September 26, 2024
LETTER OF DENIAL

RE: 691 S Bayview Ave, Freeport, NY

Building Permit Application #20243871

Description – Construct new (4,829.71SF) 3-story house with attached garage, 2 front balconies (42.6 SF each), 2 rear decks (188.94 SF & 189.09 SF) and maintain hot tub.

PLOT PLAN
SITE INFORMATION OBTAINED FROM SURVEY PREPARED BY
AREK SURVEYING COMPANY BROOKLYN, NY - DATED 7-22-14

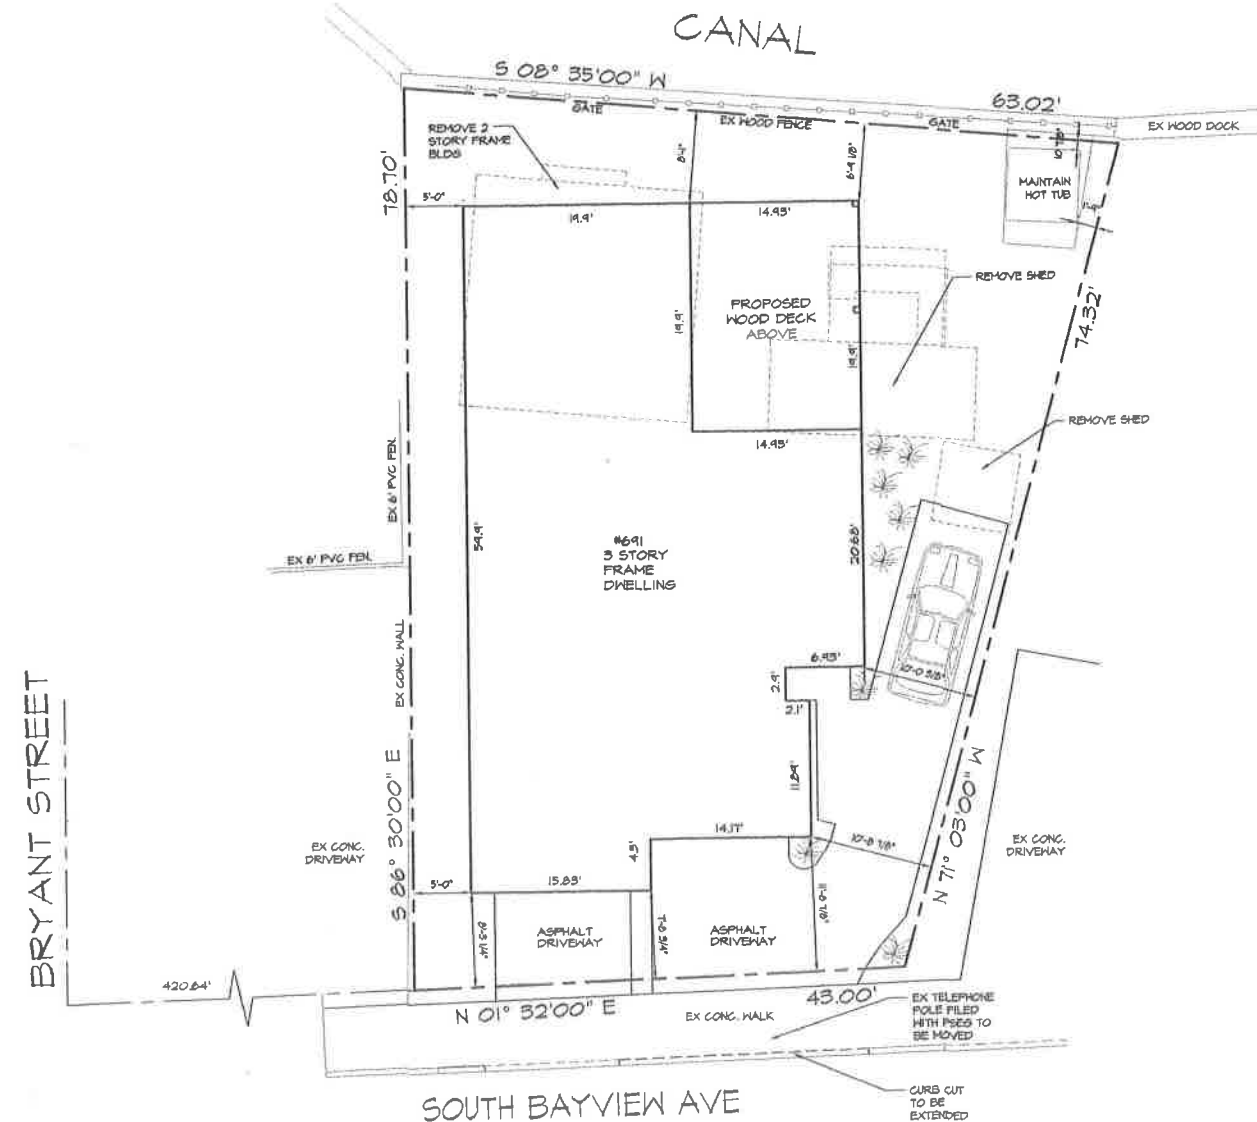
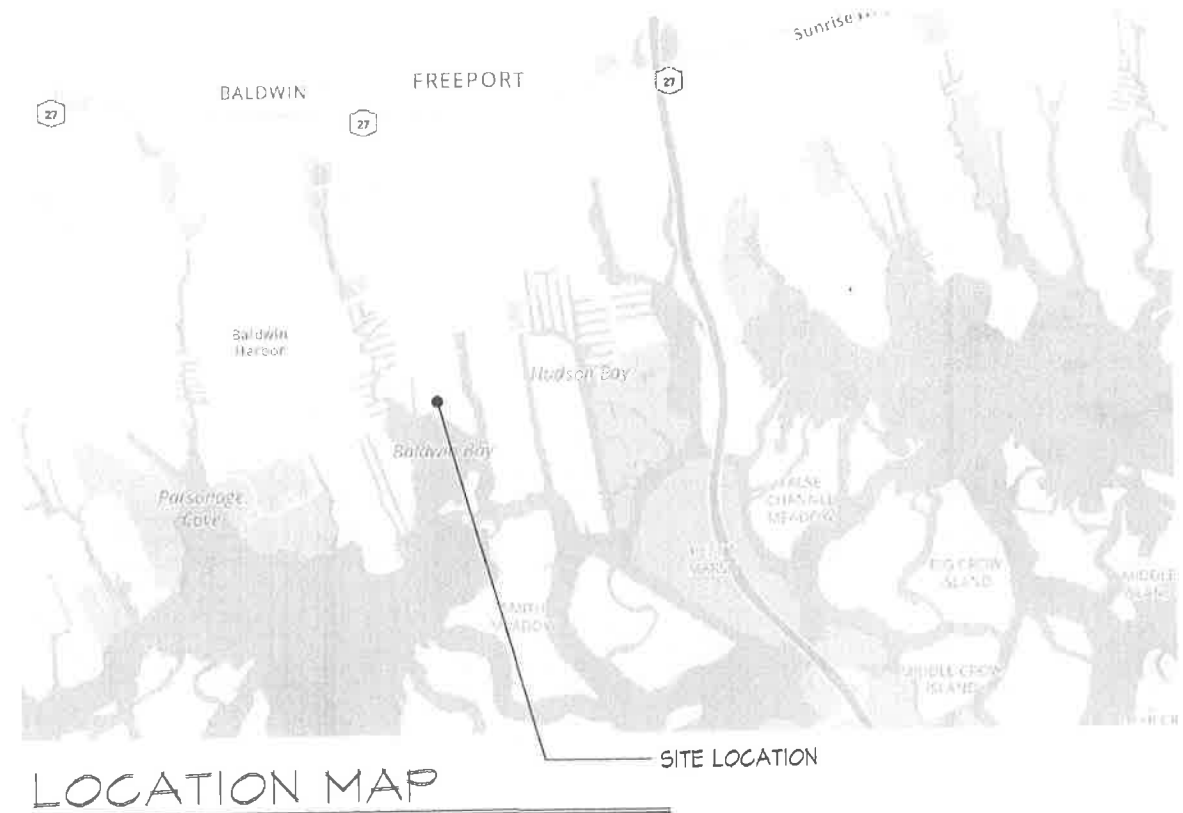
No building shall be erected on a lot whose area is less than 5,000 square feet the drawings submitted indicates that this property is 3,995 SF, you will be seeking a variance of 1,005 SF and on any lot which has a street frontage of less than 50 feet and on any lot whose width is less than 50 feet at a point between the side lines from the front property line to the rear building line of the proposed structure. The drawings submitted indicates that the street frontage is 43'. You will be seeking a variance of 7'.

10% of the total area of the lot may be used for the erection of an accessory building(s) and/or detached garage with the aggregate maximum lot coverage of said accessory building(s) and/or detached garage to be limited to a maximum of 500 square feet, and no more than an additional 5% of the total area of the lot may be used for the erection of an unenclosed porch with the aggregate maximum lot coverage of said porch to be limited to a maximum of 250 square feet. The floor area of the principal building shall not exceed a floor area ratio of 50% of the lot area. The drawings submitted indicates that the lot area is 48.18% when only 30% is permitted. The floor area of the building is 4,892.71 and only 1,997.5 is allowed. You will be seeking a variance of 2,895.21.

(1) Front yard depth: minimum 20 feet or the average depth of all residential front yards on the same side of the street within two hundred 200 feet in either direction, whichever is greater, but in no case more than 40 feet. The drawings submitted indicates that the front yard is 7'-8 3/4" including the attached front decks. You will be seeking a variance of 12'-3 1/4".

(2) Rear yard depth: minimum 20 feet or 20% of the lot depth, whichever is greater, with the exception that for lots abutting canals and other navigable bodies of water, the rear yard depth shall equal the average depths of all residential rear yards abutting the water on the same side of the canal or navigable body of water within 200 feet in either direction or 20 feet measured landwards of the average line of the bulkhead, whichever is greater, or, if no bulkhead exists, measured 20 feet landwards of the rear property line, whichever is greater. The drawings submitted indicates that the rear yard is 6'-9 1/8" including the attached rear decks. You will be seeking a variance of 13'-2 7/8".

(2) Rear yard depth: minimum five feet, except for lots which abut canals or navigable waters, a minimum depth of 20 feet measured landwards of the average line of the bulkhead shall be provided; if no bulkhead exists, measured 20 feet landwards of the rear property line. The drawings submitted indicates that the hot tub is 10" off the bulkhead. You will be seeking a variance of 19'-2" for the hot tub.

PROPOSED FRONT ELEVATION
SCALE: = 1/4" = 1'-0"

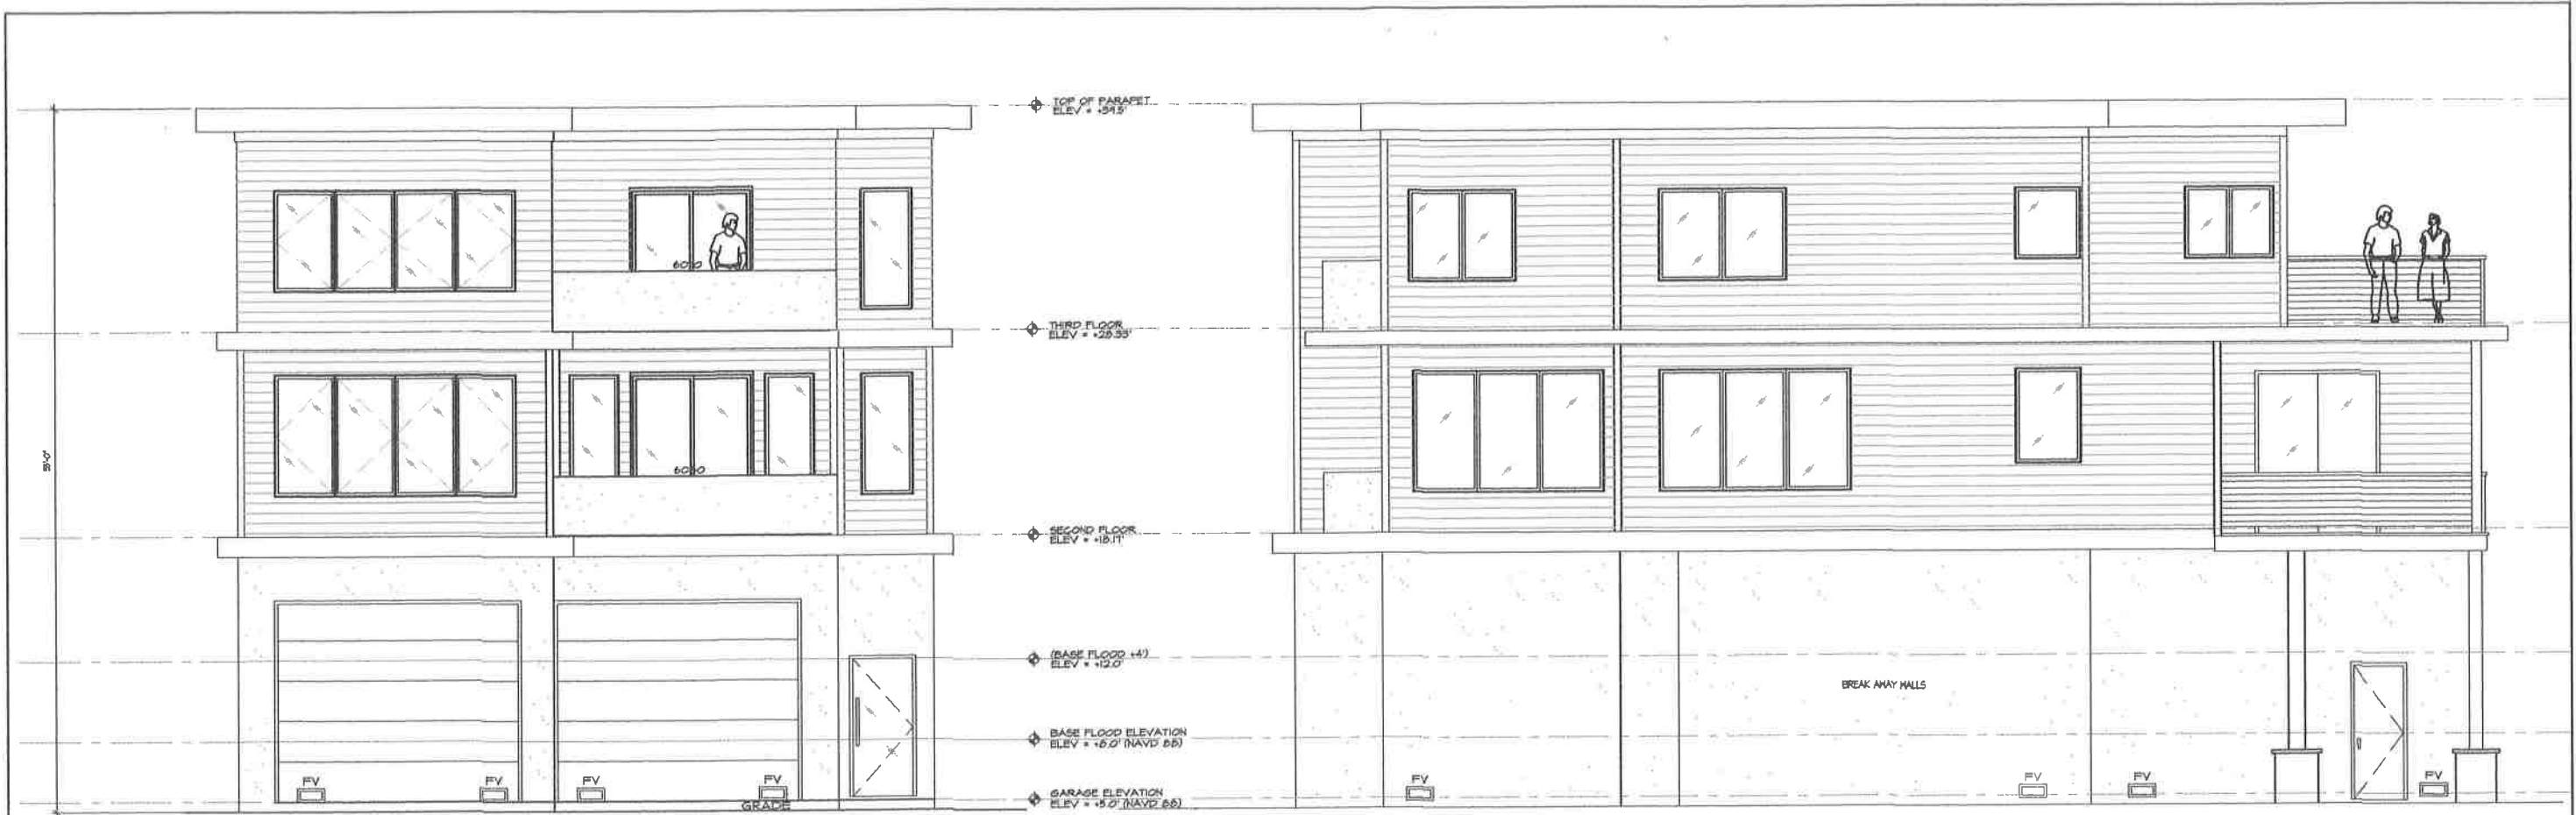
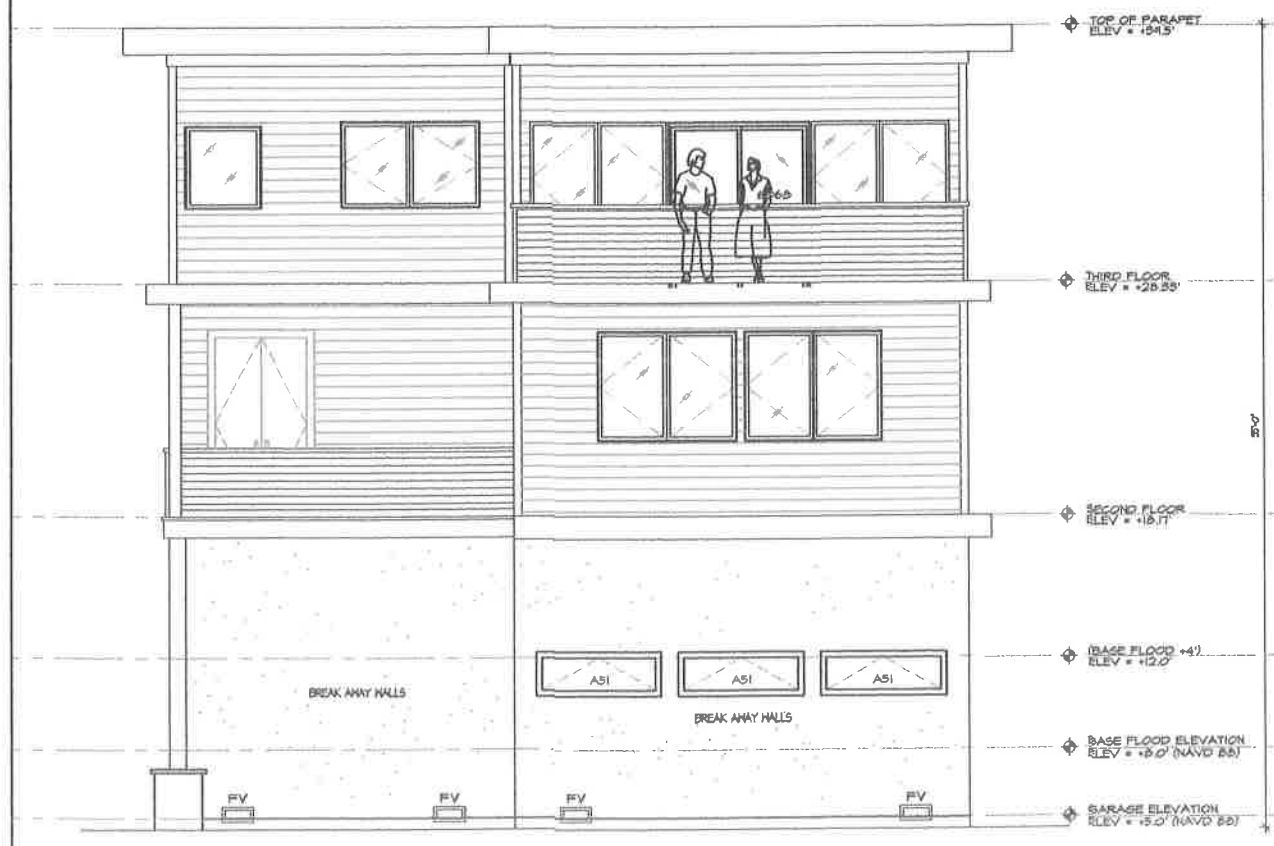
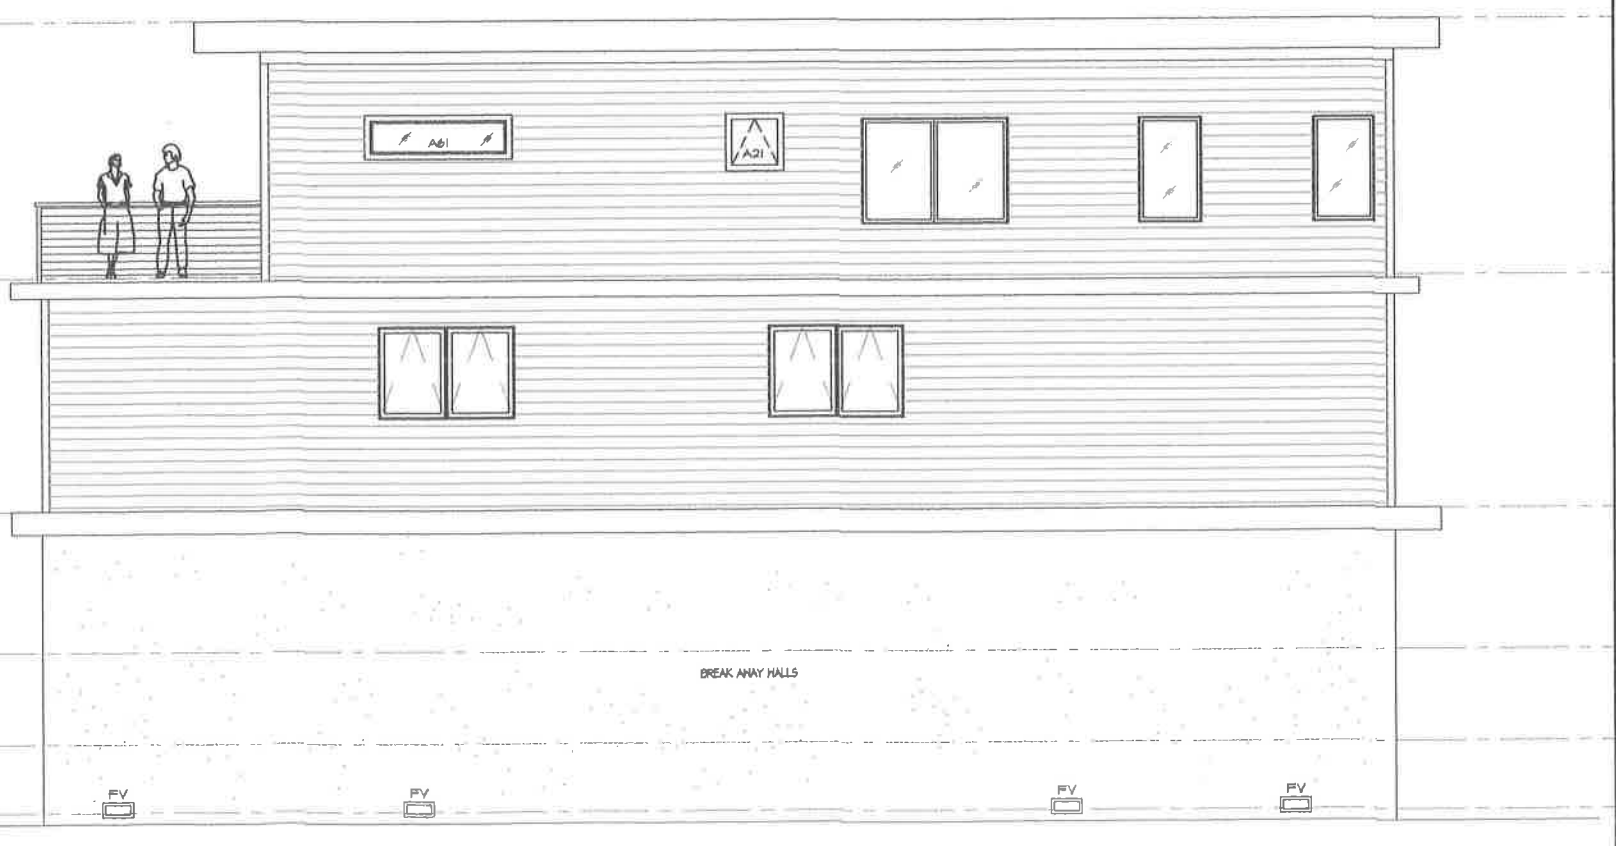
A. No dwelling shall exceed 35 feet in height nor have more than three stories, and no structure of any kind shall be erected to a height in excess of 40 feet, except that this provision shall not apply to restrict the height of a church spire or belfry or of a monument, flagpole, water tank, elevator bulkhead, or stage tower or home television or radio receiving aerial. No building shall penetrate the sky exposure plane, except for those portions as permitted in § 210-3. No accessory building and/or detached garage shall exceed 15 feet in height if erected with a roof pitched less than six units vertically to 12 units horizontally, and 20 feet in height if erected with a roof pitched six units vertically to 12 units horizontally or steeper.

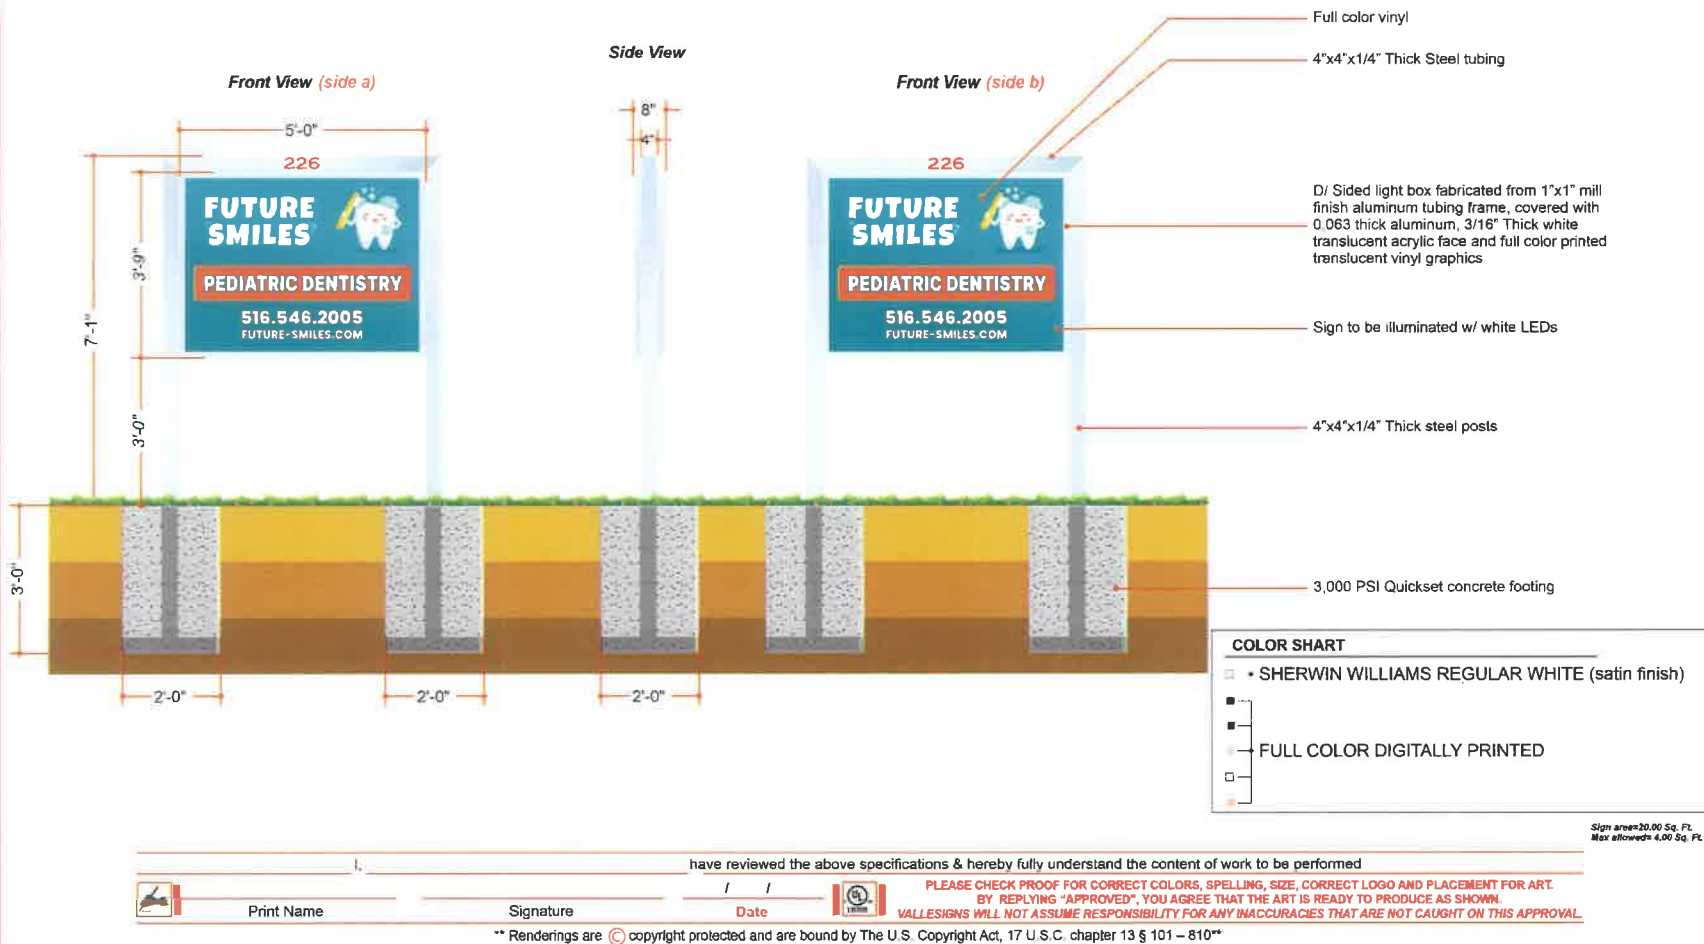
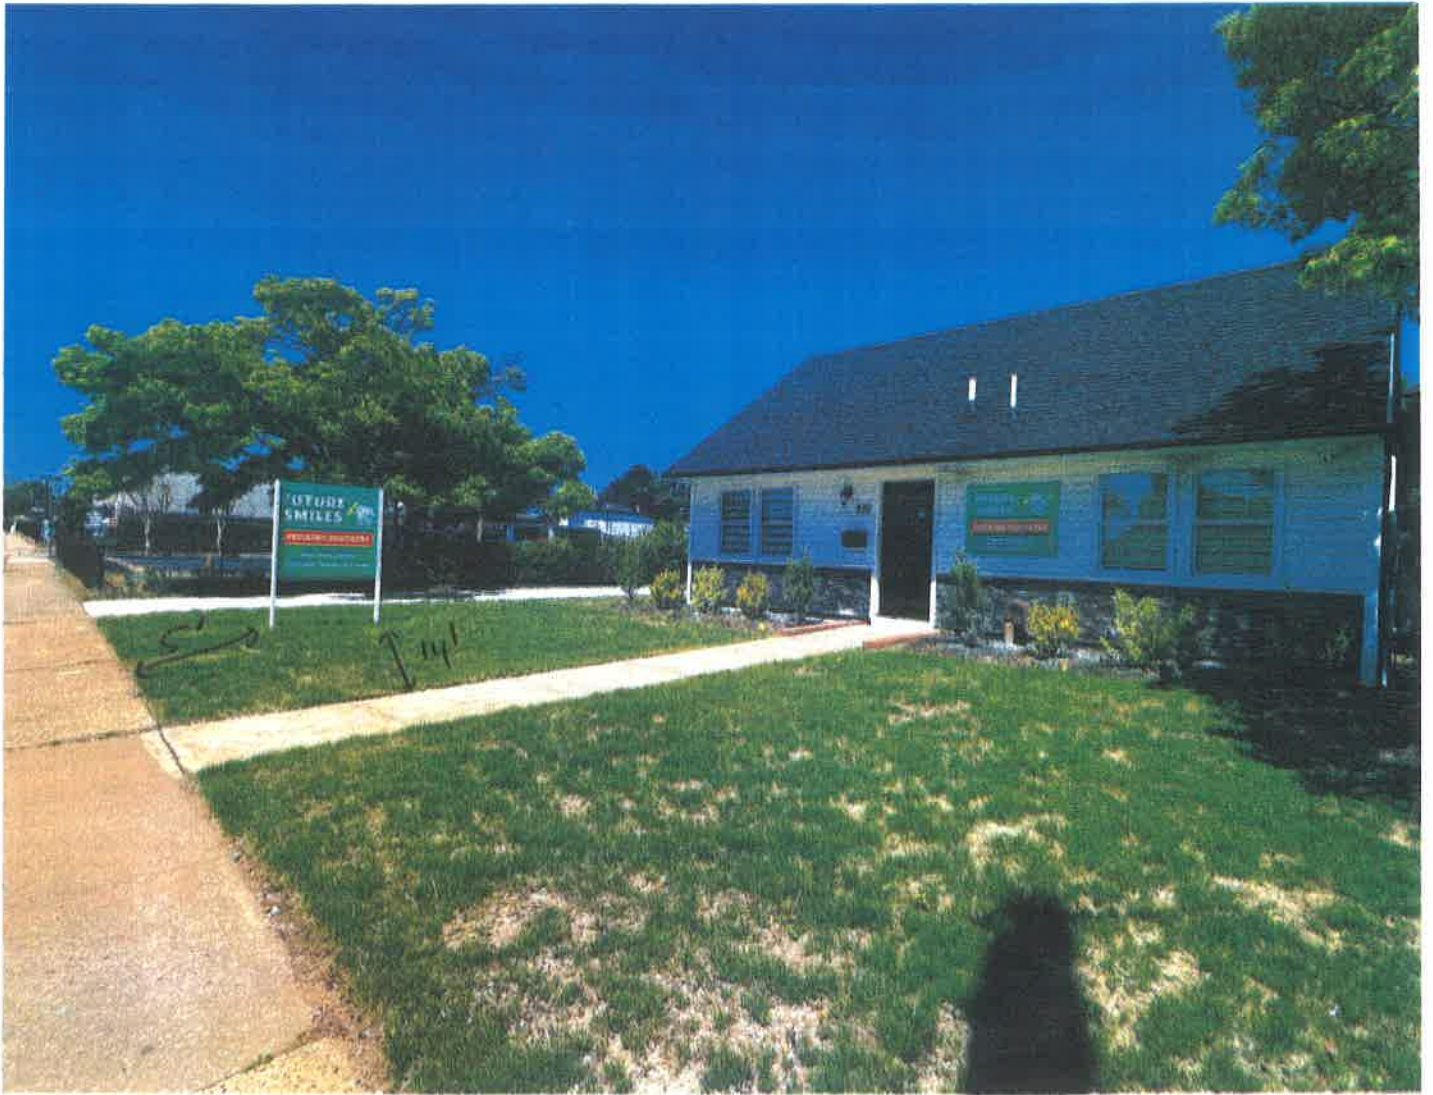
As per section 210-212 ground signs: Ground signs shall be limited as follow to a maximum 6ft in height and maximum size of 4SF. According to what you have submitted the proposed sign is 7'1" high and has a square footage of 18.75SF minus 3' of height of posts. You will be seeking a variance of 1'1" for height and 14.75SF for the square footage.
